Information on Stage Kit TMAP Sensor Modification

TECHNICAL SERVICE BULLETIN

Reference Number(s): 09-06-04-009, Date of Issue: March 02, 2009

Affected Model(s): 2008-2009 HHR SS; Equipped with 2.0L Engine (VIN X - RPO LNF)

Fig. 1: View Of Duct

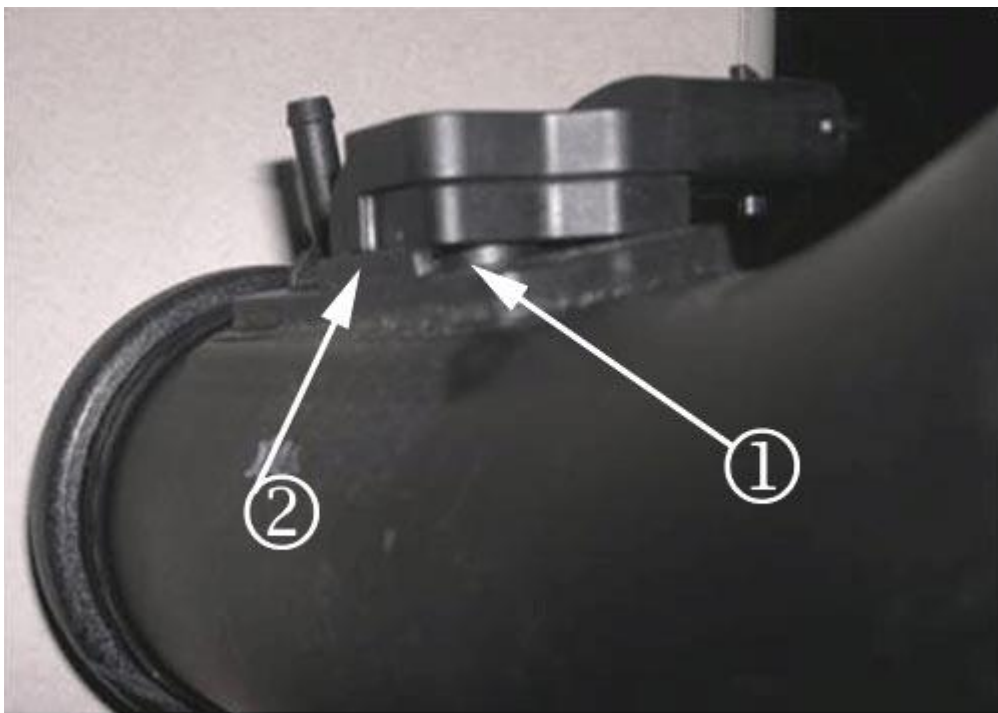
NOTE: When installing the GM Performance Parts accessory upgrade Stage I Turbo kit # 19212670 on a 2008-09 HHR SS, the intake air pressure temperature (TMAP) sensor interferes with the charge air cooler (CAC) pipe. The TMAP sensor is located on the charge air duct between the intercooler and the engine. The sensor requires modification before assembly or leaks may occur. Following these steps will prevent any concerns when mounting the TMAP to the duct pipe.

Inspect the TMAP sensor when mounted on the charge air duct. Note how the TMAP sensor is not mounted flush on the duct (1).

Fig. 4: View Of Mounted TMAP Sensor

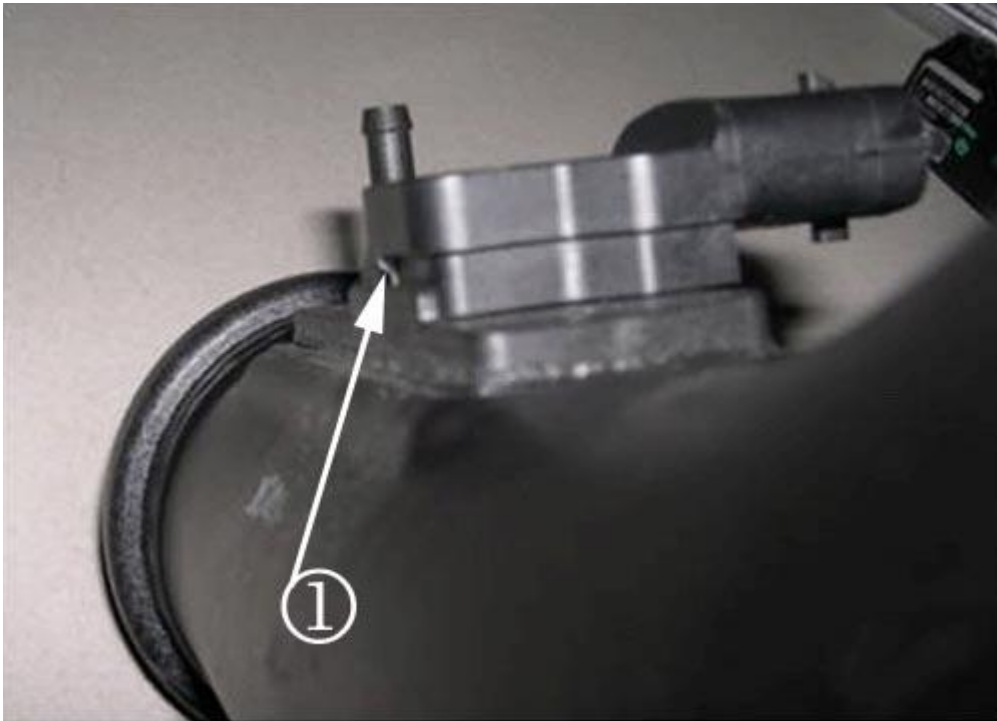
Carefully remove the boss (1) until the TMAP will mount flush on the duct. The boss interferes with the anti-rotation bar on the duct.

The TMAP sensor mounted flush onto the duct (1).
